Visa International Mini Jets ride – modification to lower levelling bars

Regarding failure on Mini Jet Ride

Instant modification on lower leveling bar of mini jet rides.

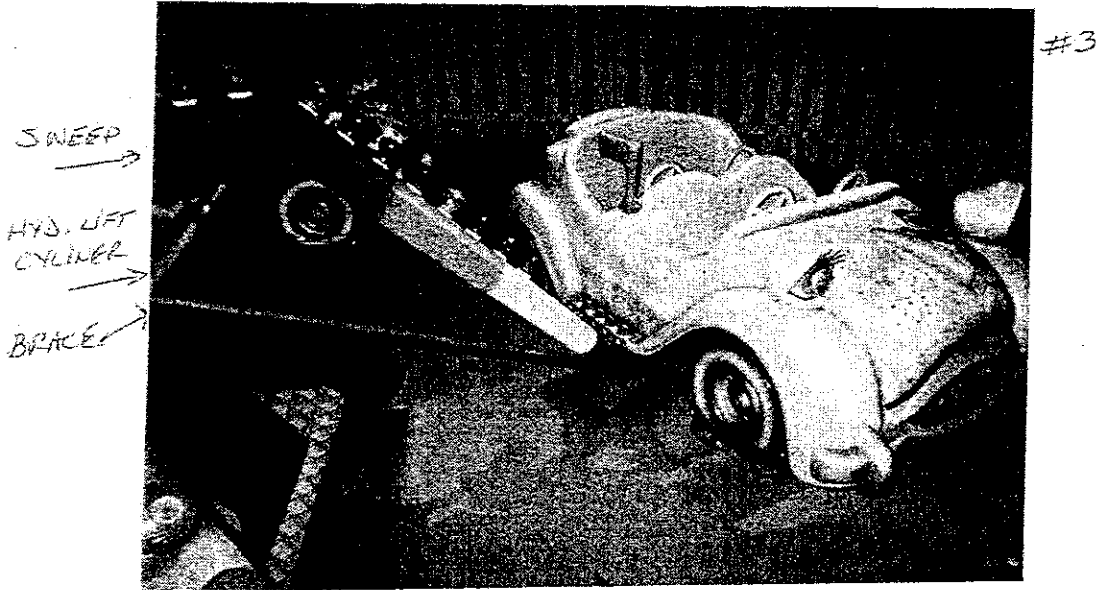
Dear Mike Reinhart, after reviewing you fax from Nov. 18.2002, an instant modification on the mini jet rides has to be to add 2 grease fittings on each of the upper support of the leveling bar (center hub connection). For this the leveling bars have to be dismantled two holes have to be drilled on each sweep (left and right side of tubing) and two grease fittings have to be added per support.

Before installation of leveling bars, the bars have to be visually inspected for any deformation and the top pin (center hub side of the bar) has to be sanded, cleaned and greased.

These grease points have to be greased every 40 operational hours.

We feel that after this instant modification a seizing of the upper joint of those bars can be eliminated, and the ride can be operated safely.
